Project: MU/Patient Care Tower-1230- MRI Room

Subject: Addendum No. 1

ADDENDUM #1

TO CONTRACT DOCUMENTS FOR: Project #CP245321 – Patient Care Tower – T1230 MRI Room

1 PLUMBING GROUND FLOOR NEW WORK PLAN
1/4" = 1'-0"

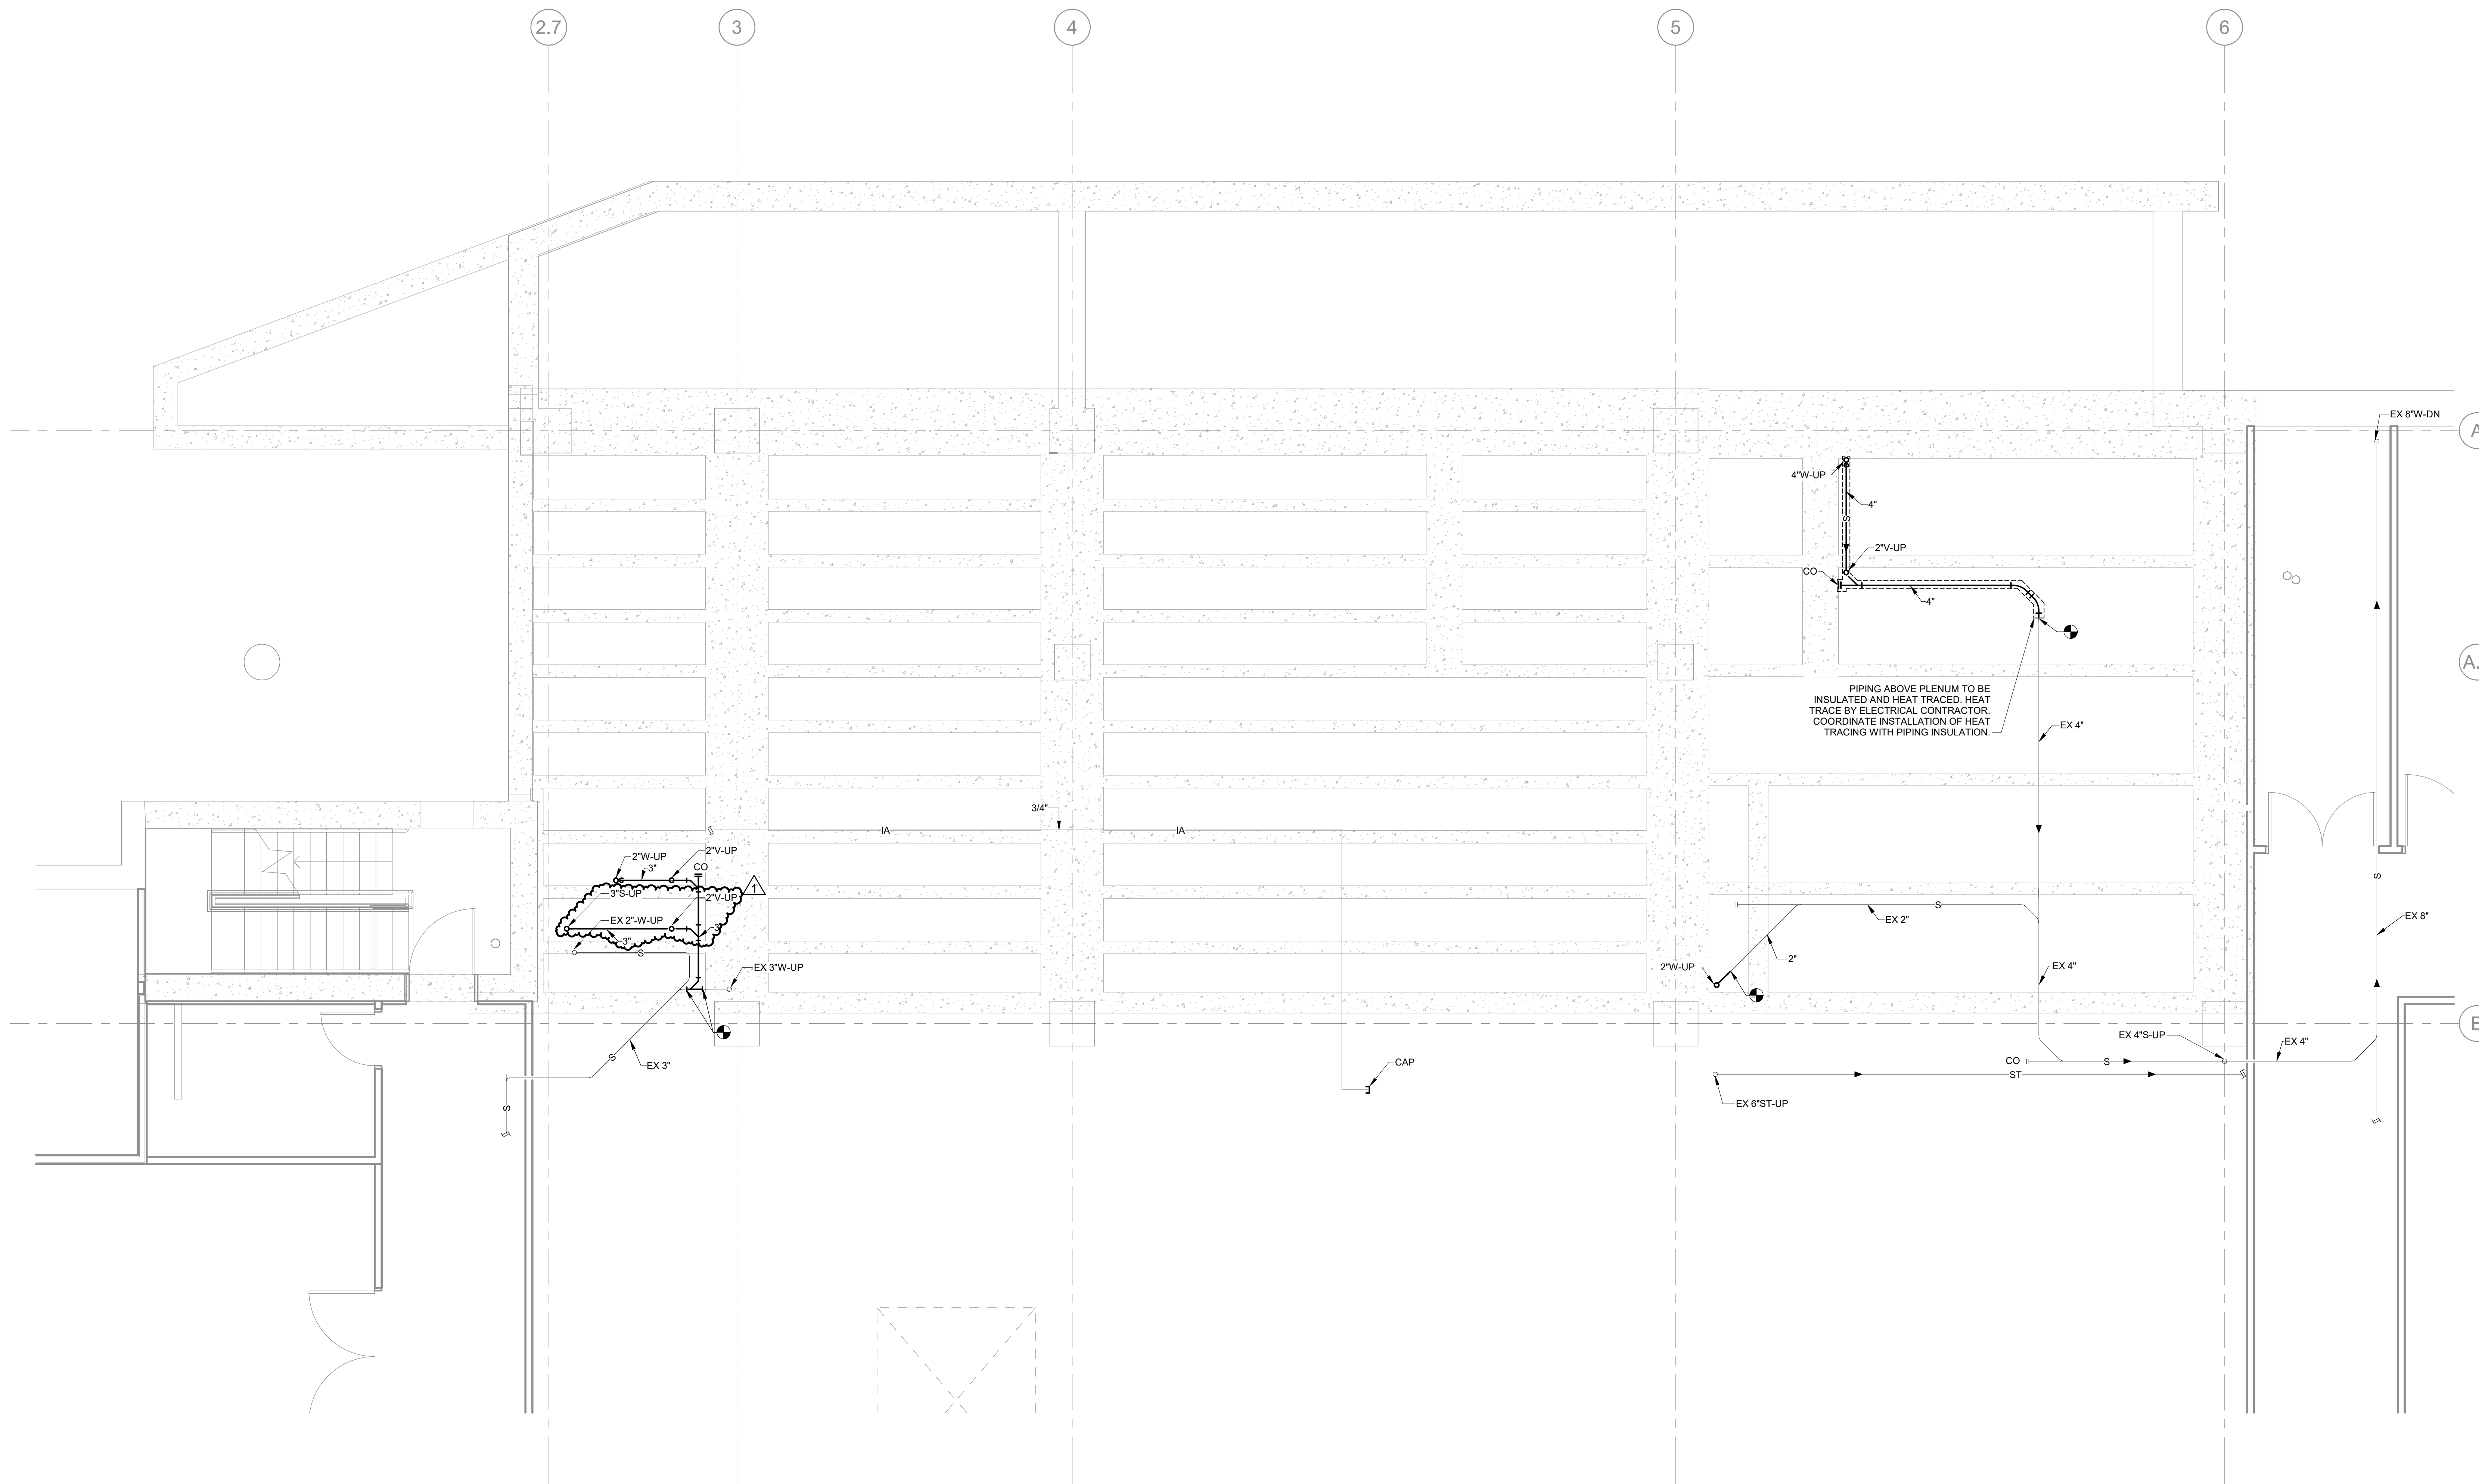
- 3) P2.3 – Plumbing Ground Floor New Work Plan
 - a. **REVISED** sanitary and vent piping.

8 BACKFLOW PREVENTER
NONE

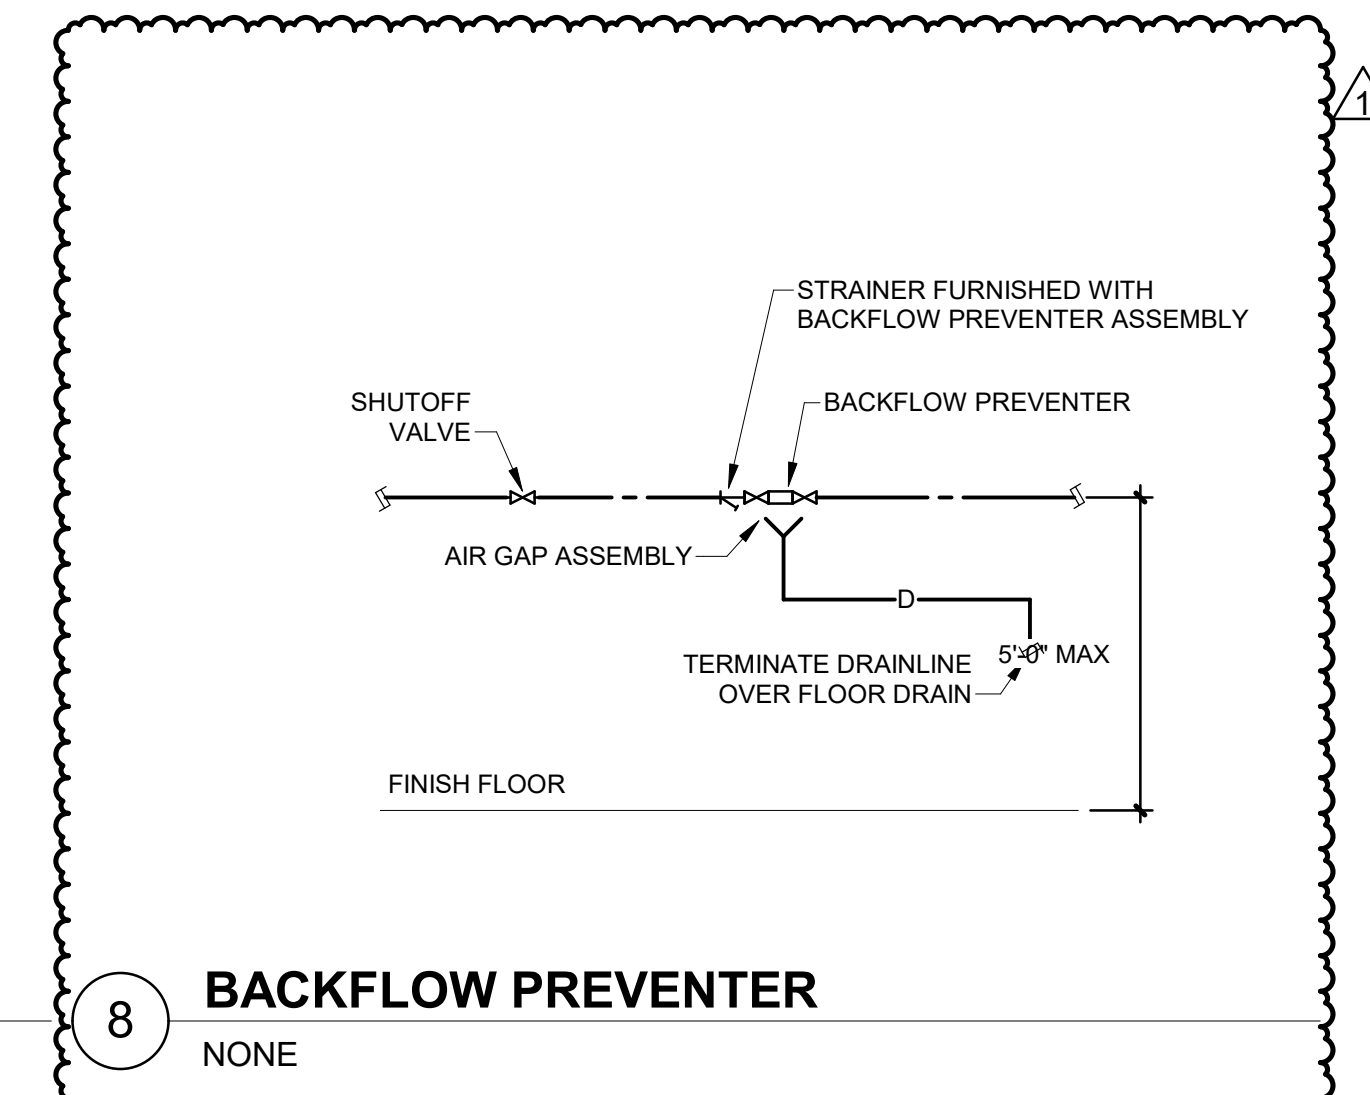
- 4) P2.7 – Plumbing Details and Schedules
 - a. **ADDED** Detail 8.

1 FIRE PROTECTION FIRST FLOOR DEMO PLAN
1/4" = 1'-0"

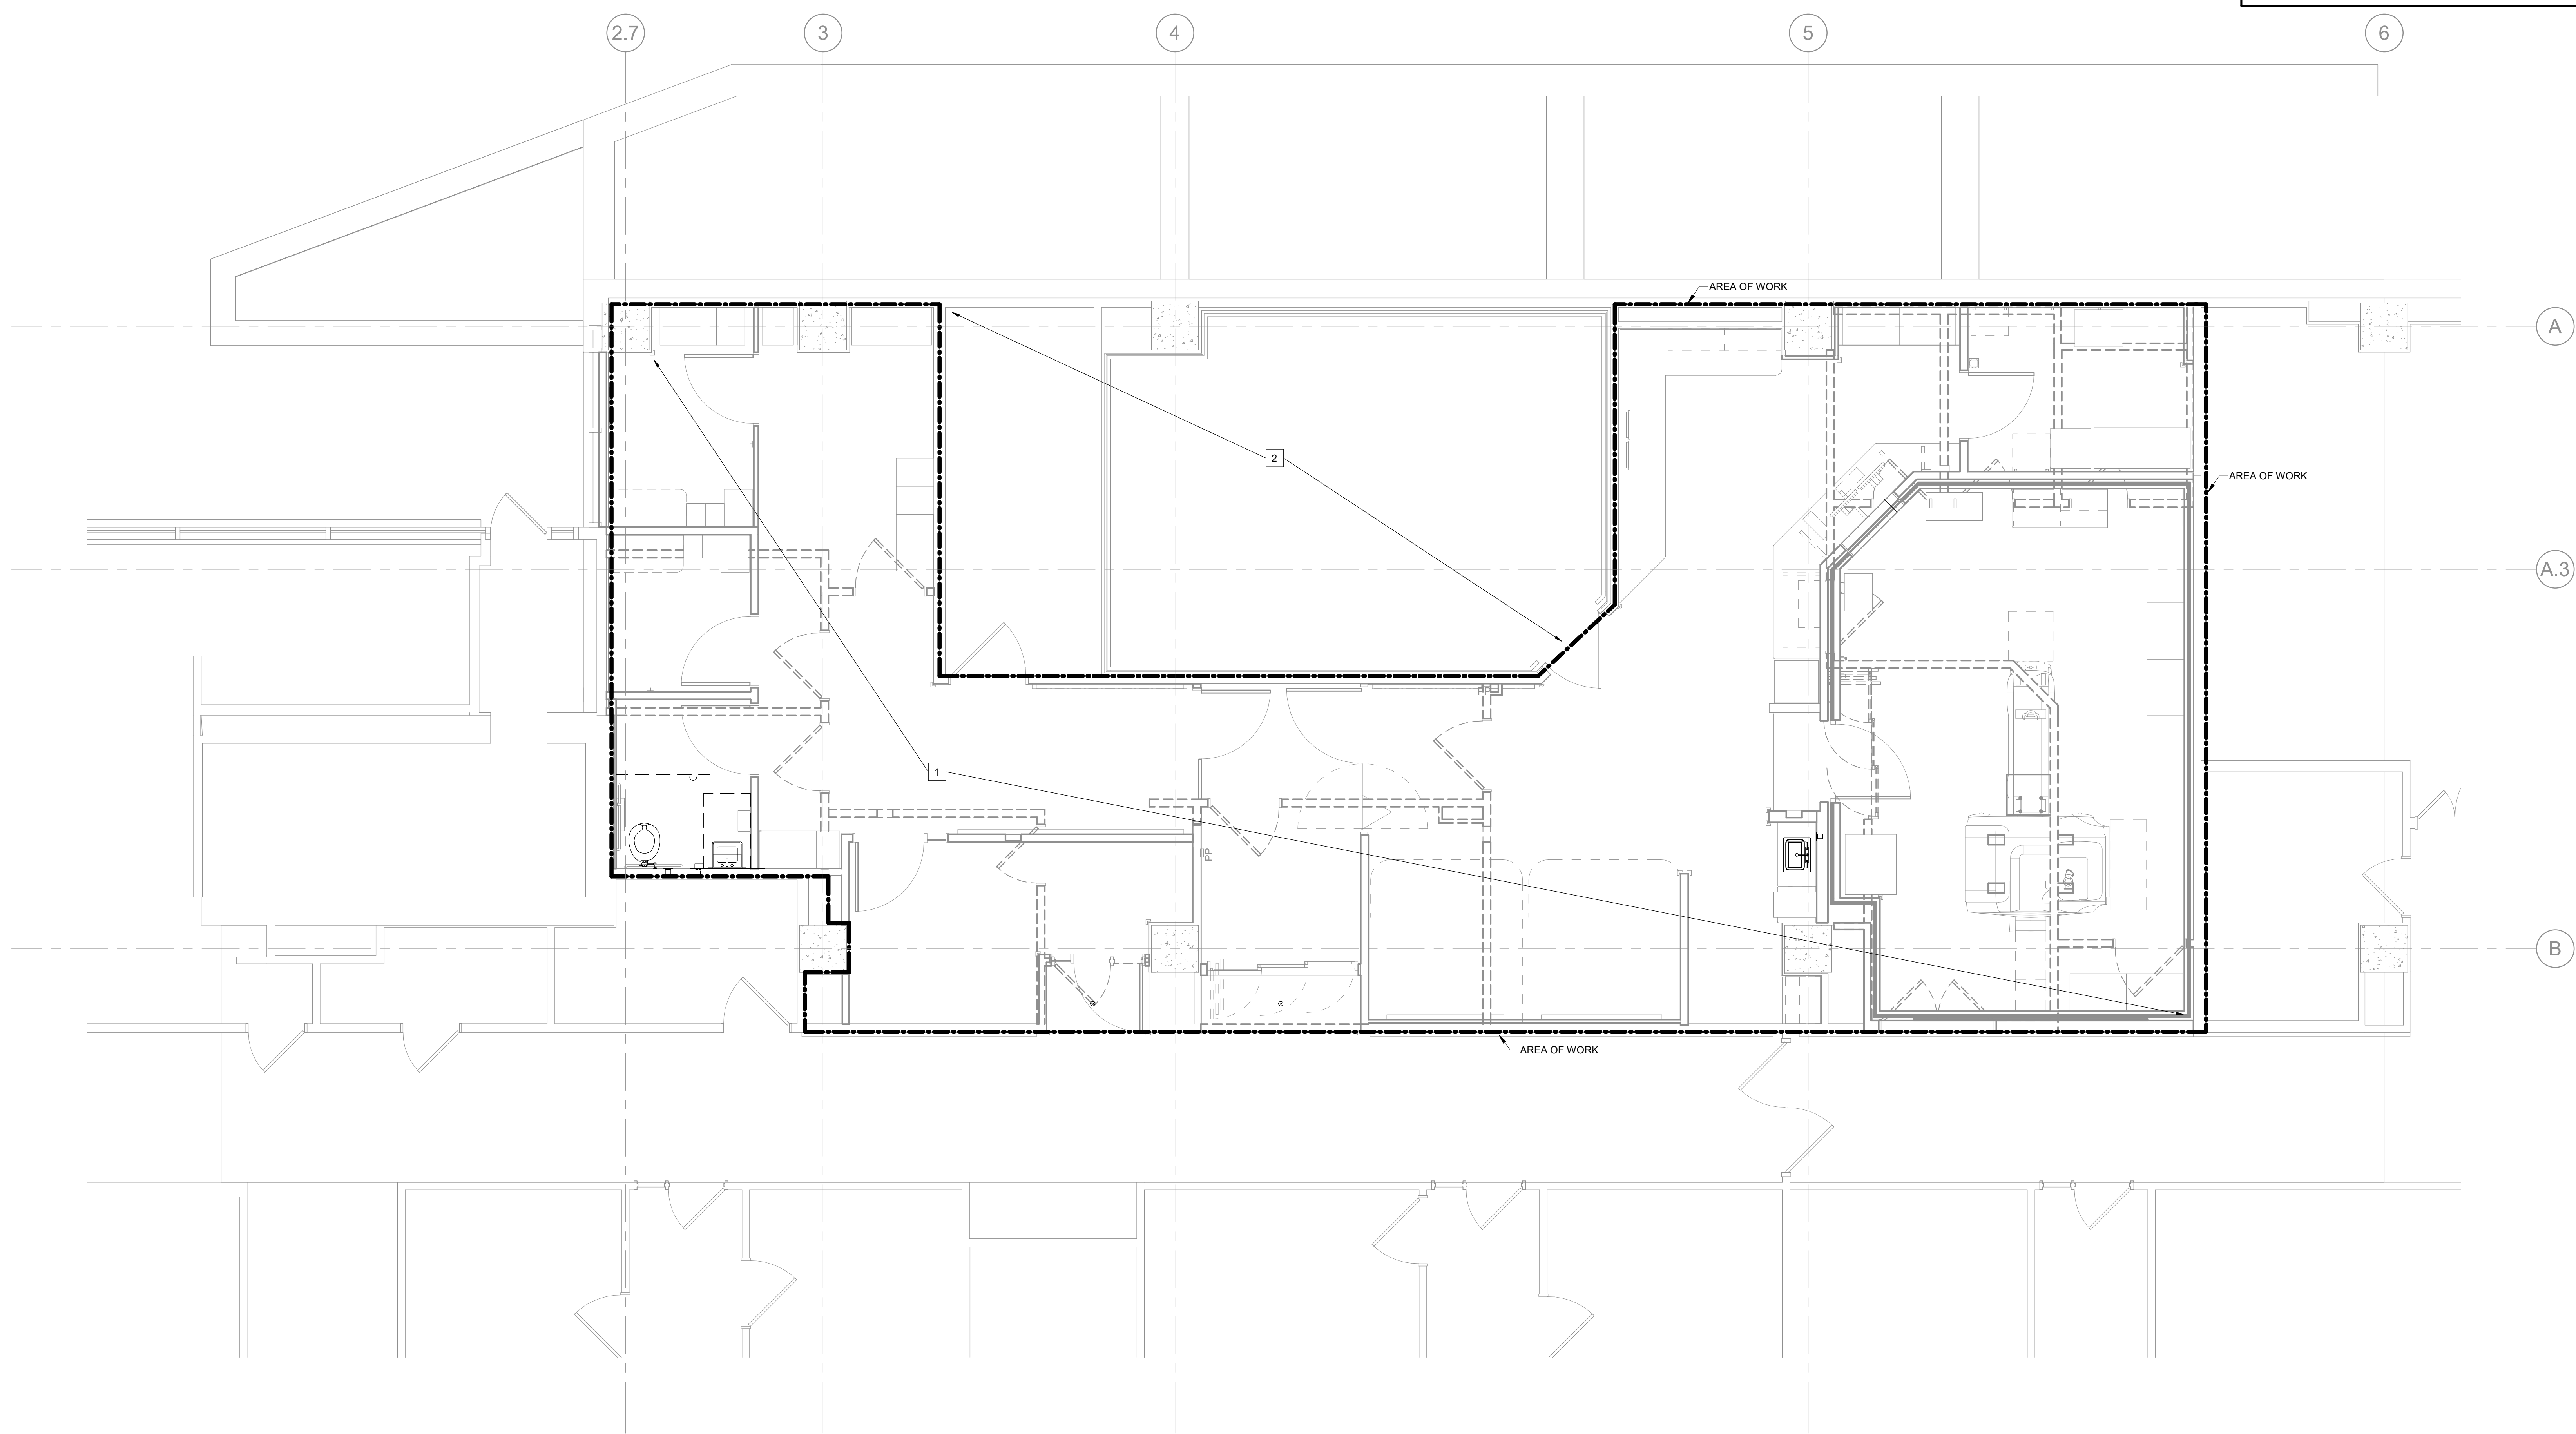
- 1) FP1.1 – Fire Protection First Floor Demo Plan
 - a. **ADDED** general note to make provision for temporary sprinkler protection during construction.
- 2) FP2.1 – Fire Protection First Floor New Work Plan
 - a. **ADDED** general note to reference architectural sprinkler head layout for coordination.
 - b. **REVISED** Keyed Notes 4 and 5.
 - c. **ADDED** Keyed Note 6.

- CONTRACTOR TO PROVIDE TEMPORARY SPRINKLER PROTECTION DURING CONSTRUCTION. PROVIDE TEMPORARY UPRIGHT SPRINKLER PROTECTION PER FM GLOBAL AND NFPA 13.
